CellComSL Series Universal Alarm Communicator

July 2015

Version 123 Firmware Update

Ademco/Honeywell ECP Bus Communication

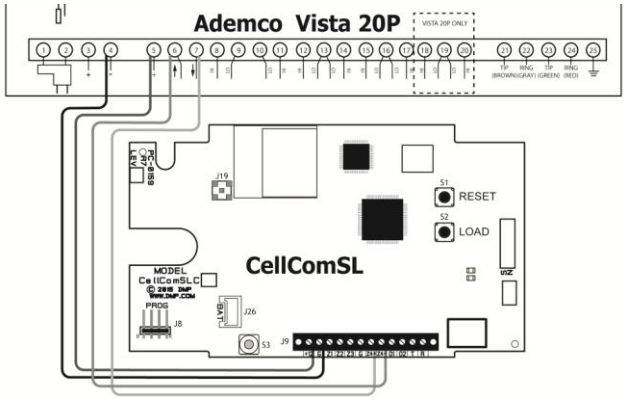
CellComSL Series Version 123 (6/10/15) firmware and Level E hardware now supports Ademco/Honeywell ECP Bus Communication. When the CellComSL is connected to the ECP Bus of an Ademco/Honeywell panel, the App user can:

- Arm and disarm the Ademco/Honeywell panel using the Virtual Keypad App and browser (Stay/Away systems only).
- Receive alarm, trouble, opening/closing and other messages from the panel and send them to the central station SCS-1R or SCS-VR receivers
- Add, delete, and change user codes in the Ademco/Honeywell panel.

ECP operation must be enabled in the CellComSL. See Keypad Input and the Ademco/Honeywell panel wiring diagram example in the CellComSL Installation/Programming Guide (LT-1339) for additional information.
